Architectural Review Board

Decision and Record of Action – June 12, 2025

App No: BZAP-25-27
Address: 410 S Columbia
Applicant: Catherine Williamson
Owner: Rebecca and Mark Dausen

Request: The applicant is seeking architectural review and a recommendation to the Board of Zoning and Planning for the approval of a Certificate of Appropriateness to replace the existing open-air breezeway, incorporate a mudroom and additional living space.

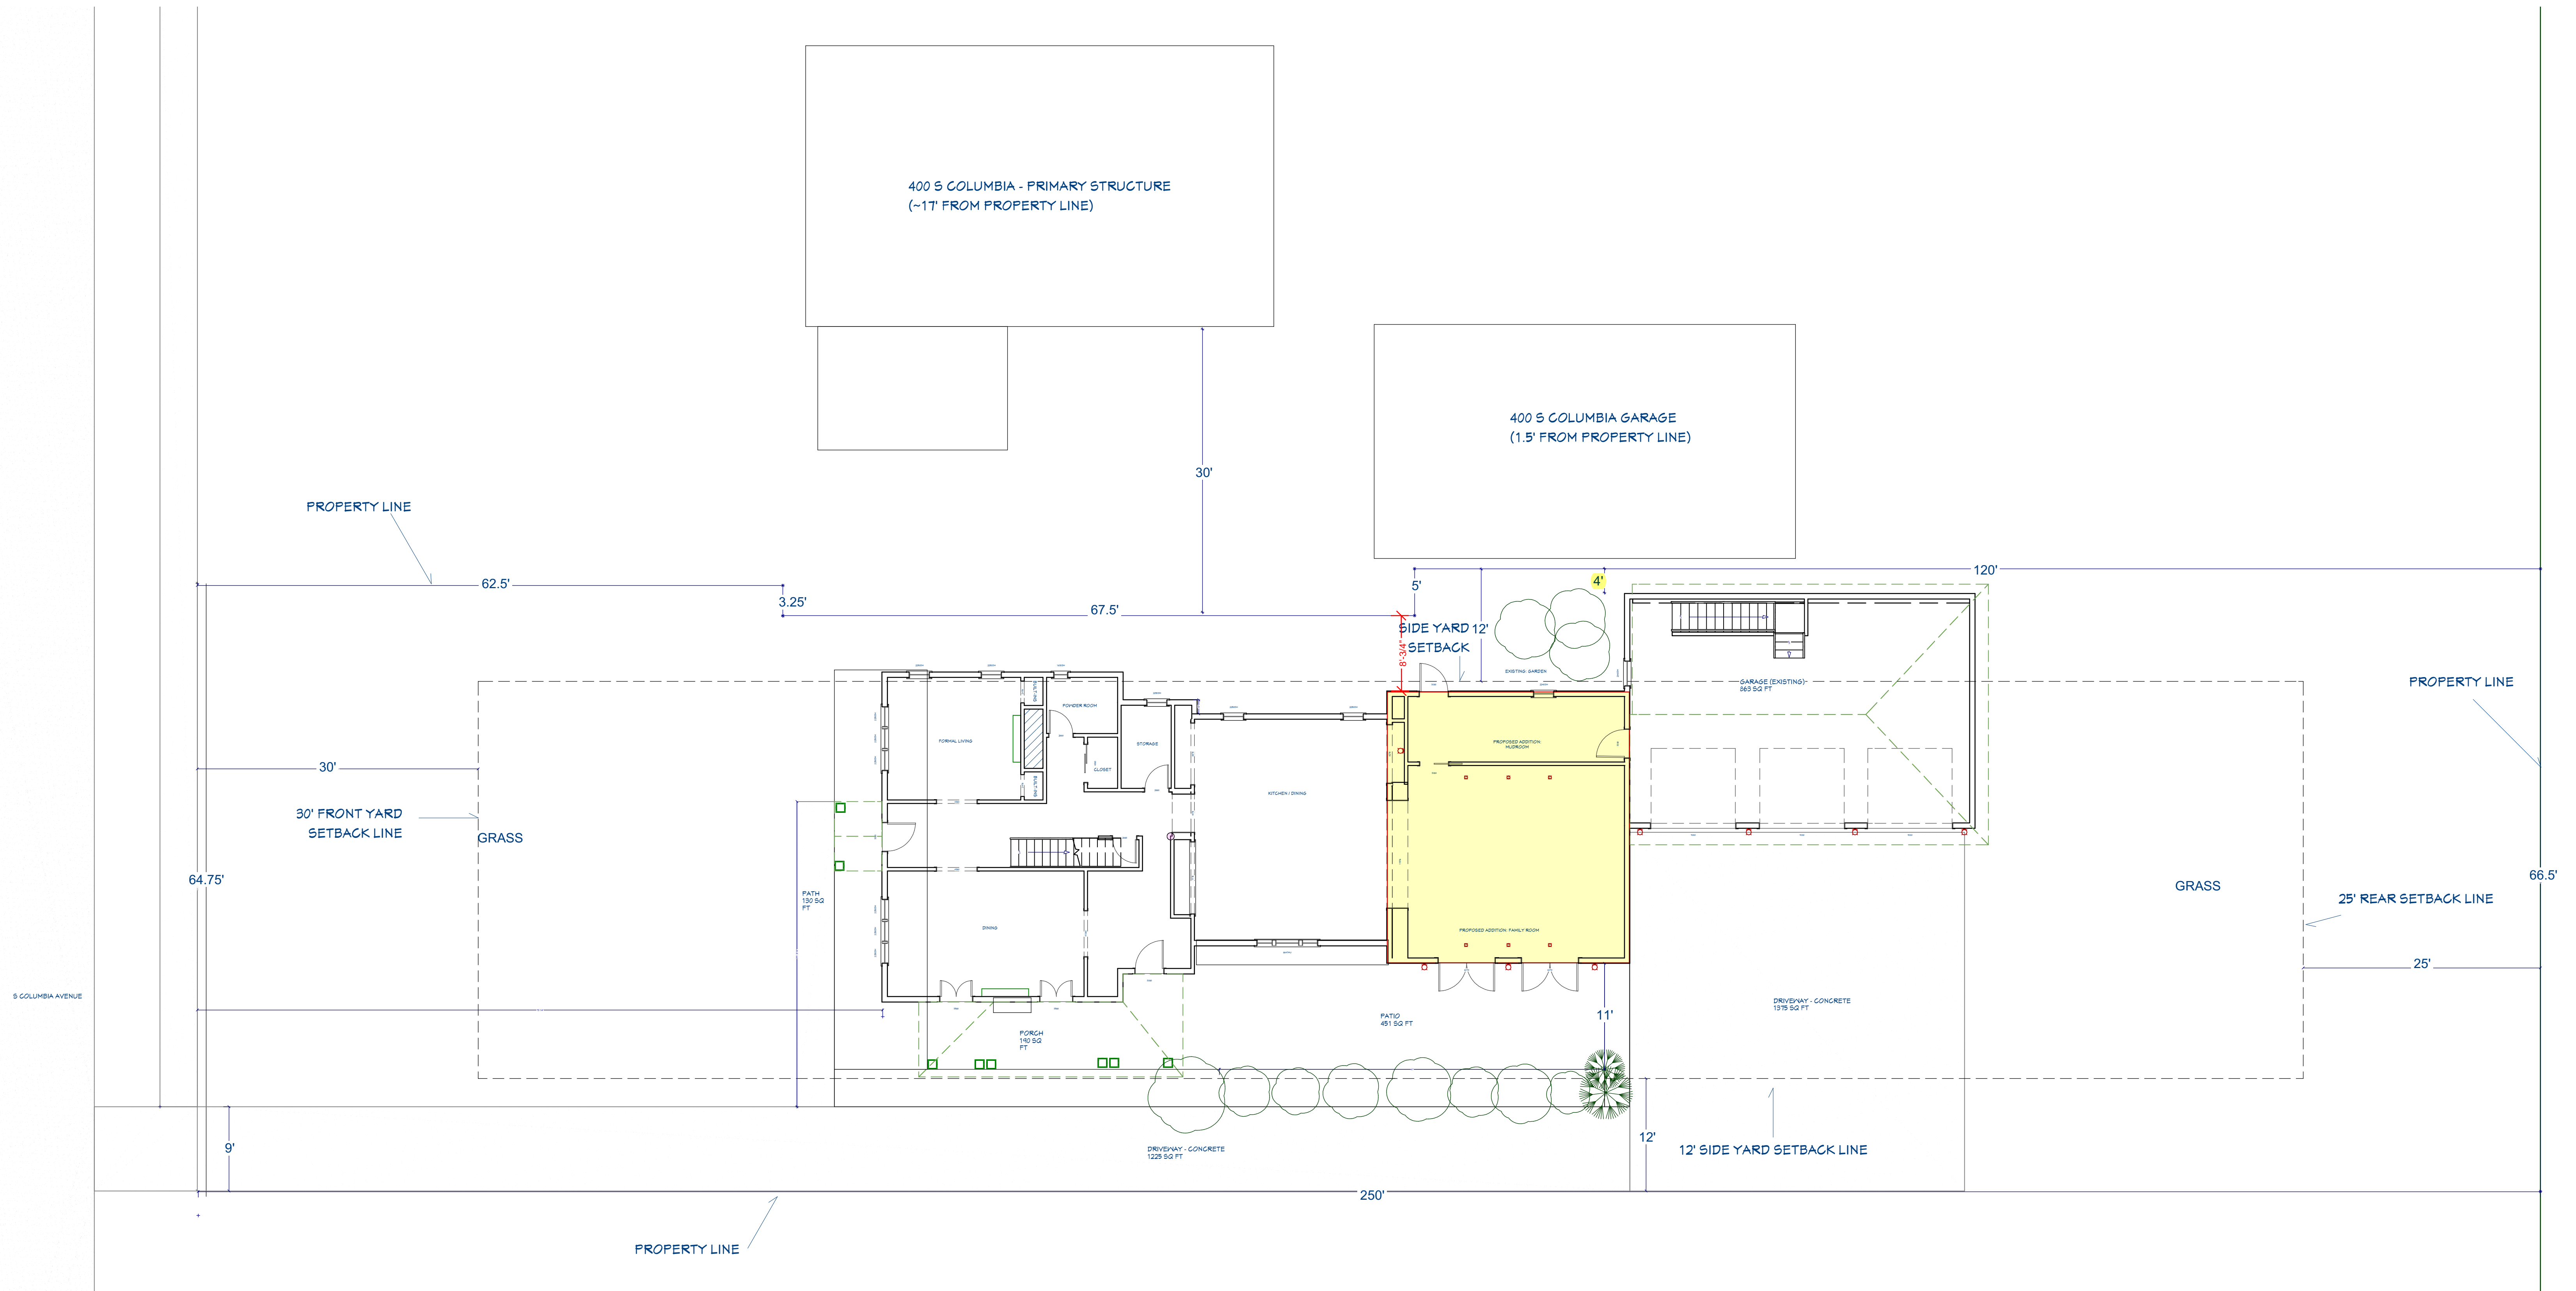
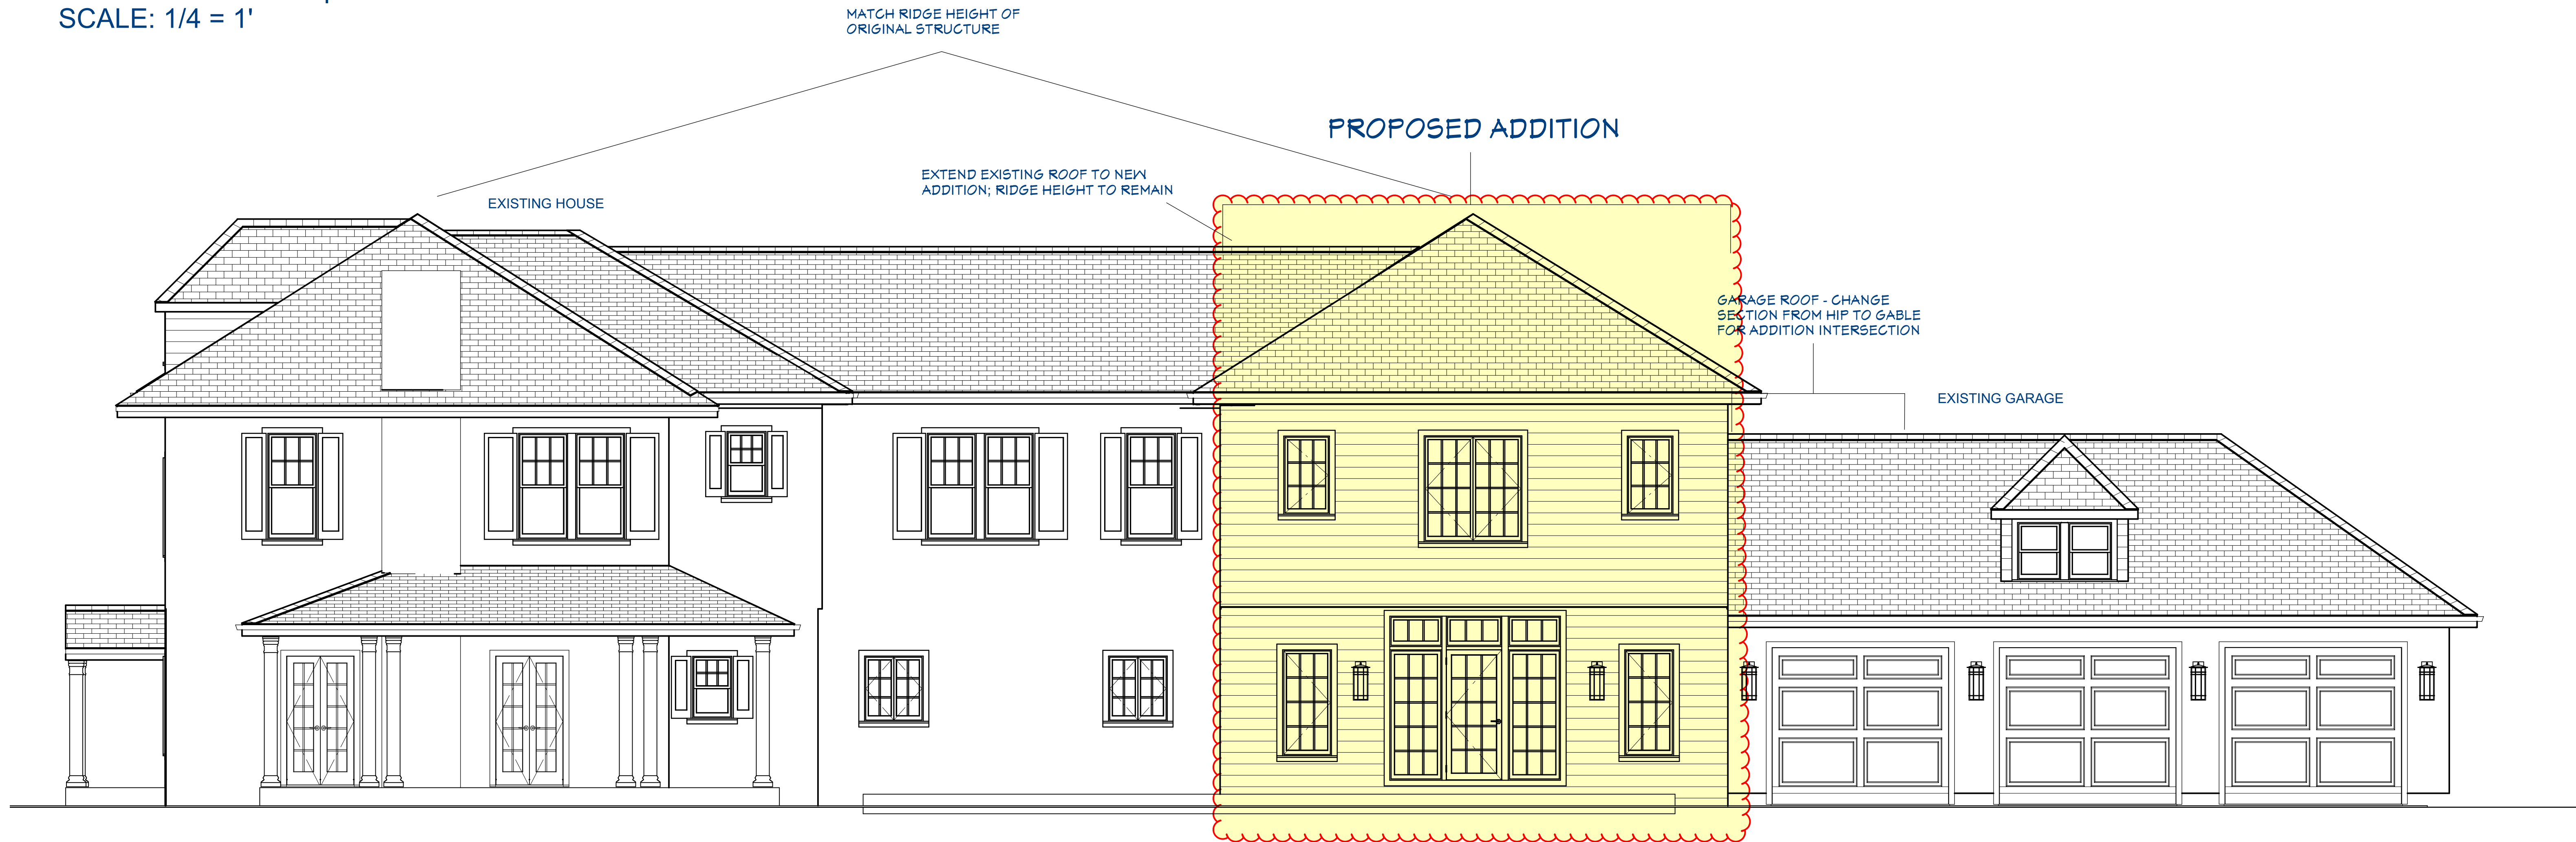
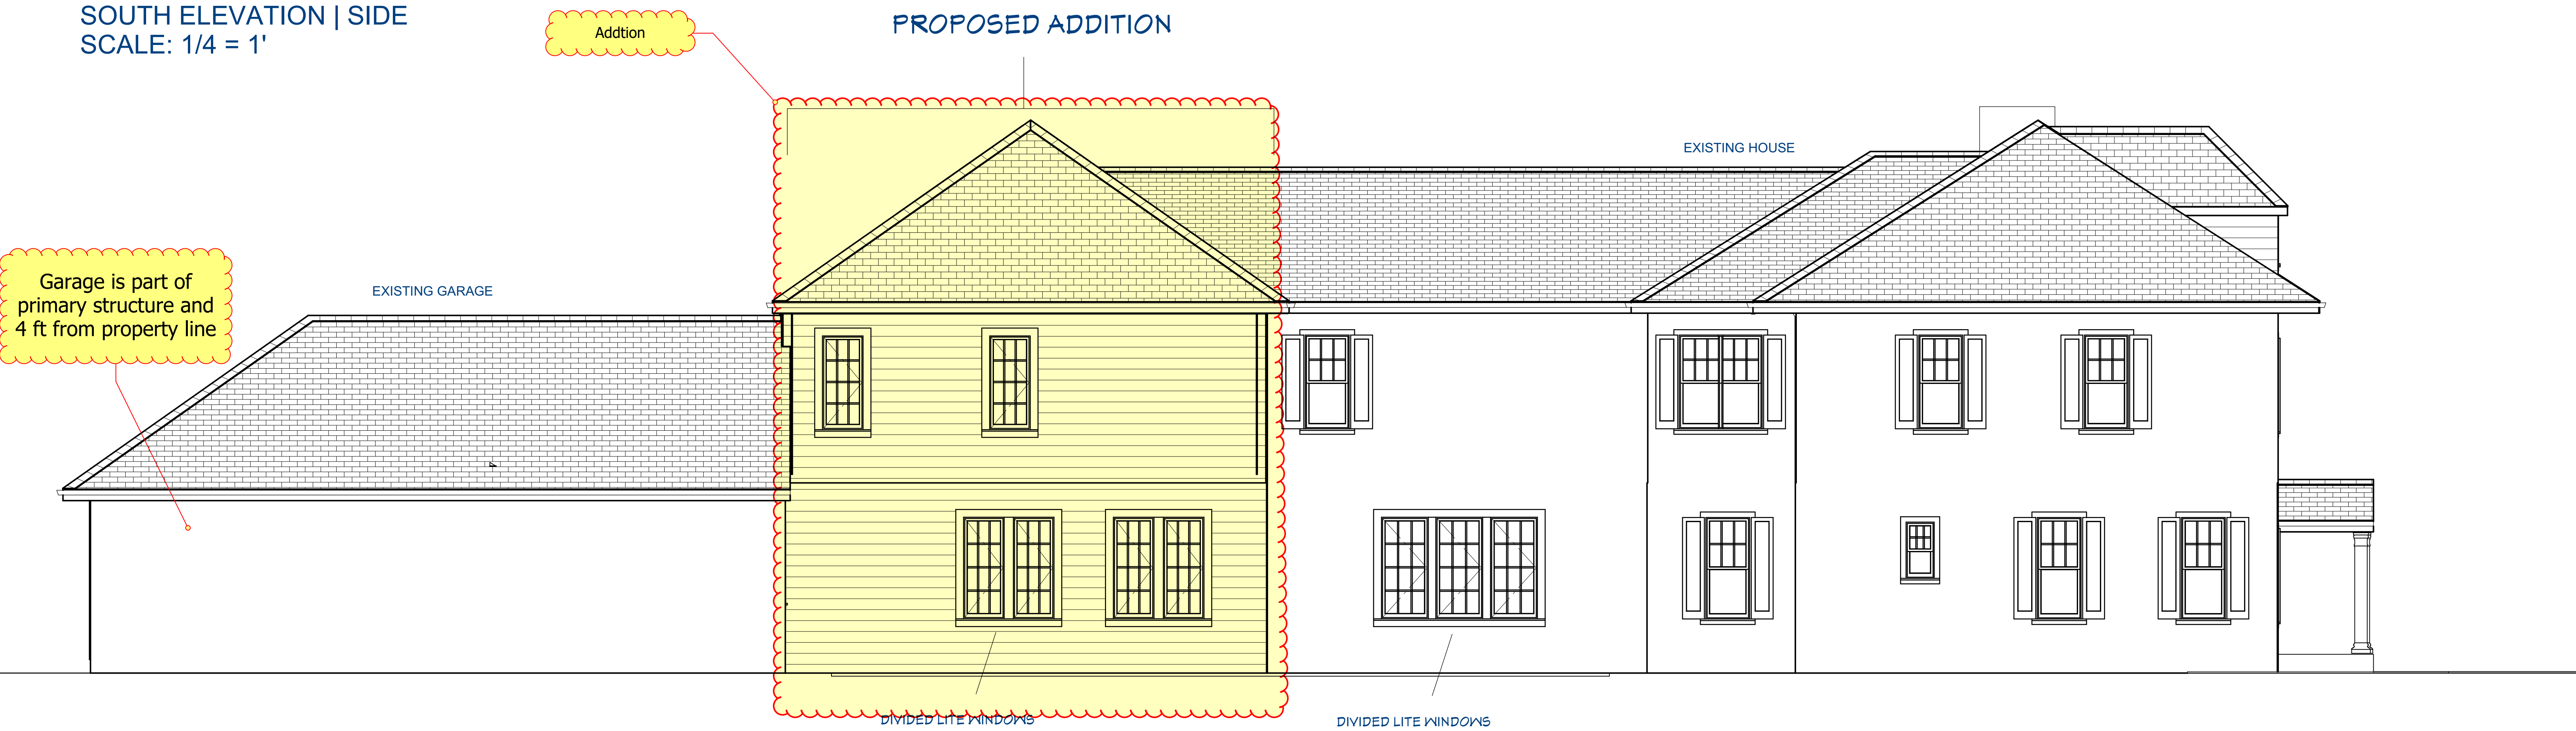
1. The addition should be stucco to match the original
2. The massing should step back and be subservient to the original structure.
3. Windows should match existing
4. All existing details should be accurately represented and new details should match original home.
